AMENDMENTS TO THE DRAWINGS:

root canal treatment tool

2/10

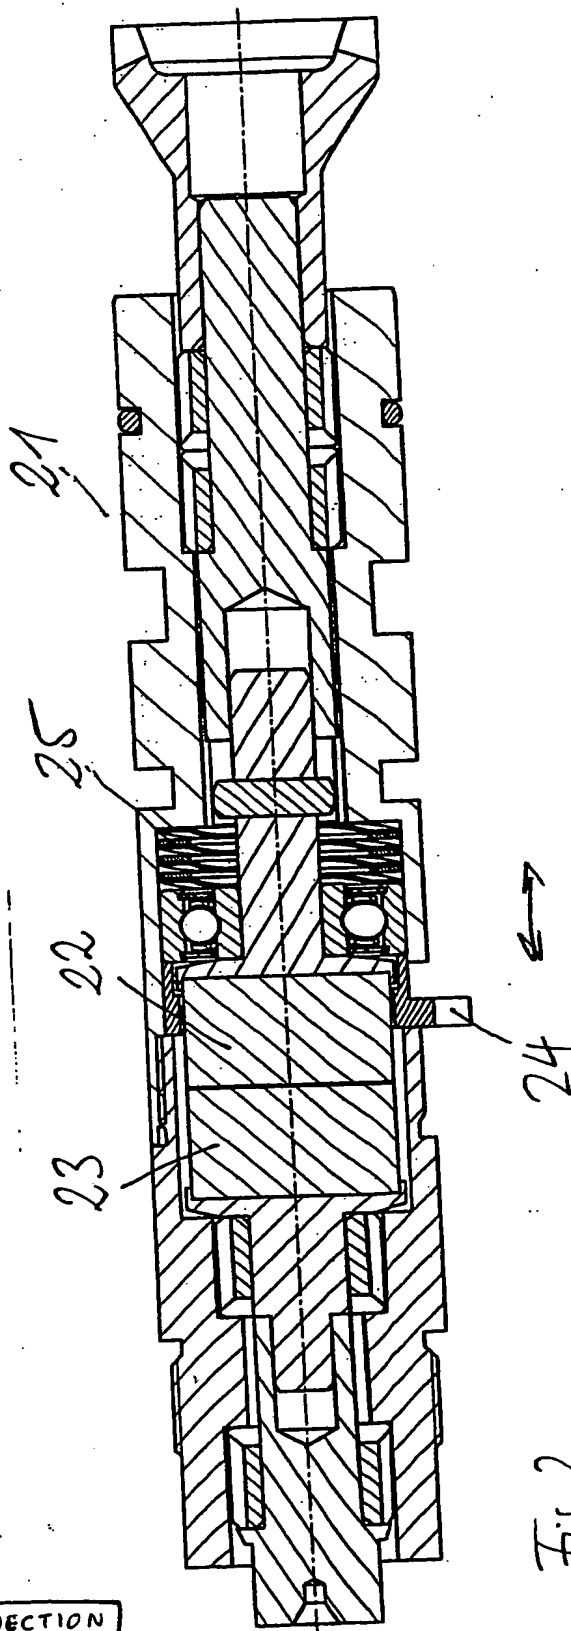
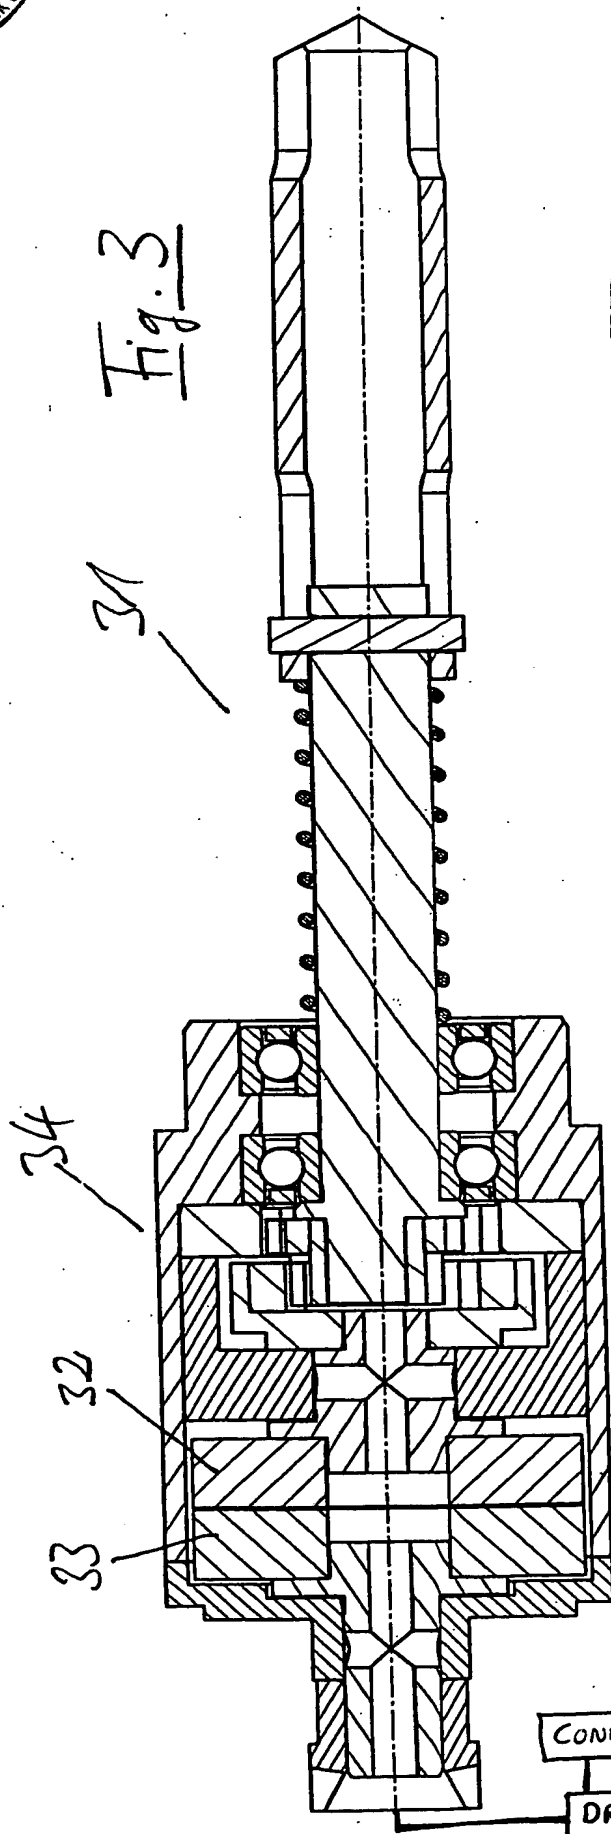
The attached sheets of drawings include changes to Fig. 3 and new Fig. 15. The sheet which includes Figs. 2 and 3, replaces the original sheet including Figs. 2 and 3. In Fig. 3, the drive motor, recited in dependent claim 12, and the connection point, recited in dependent claim 18, have been added.
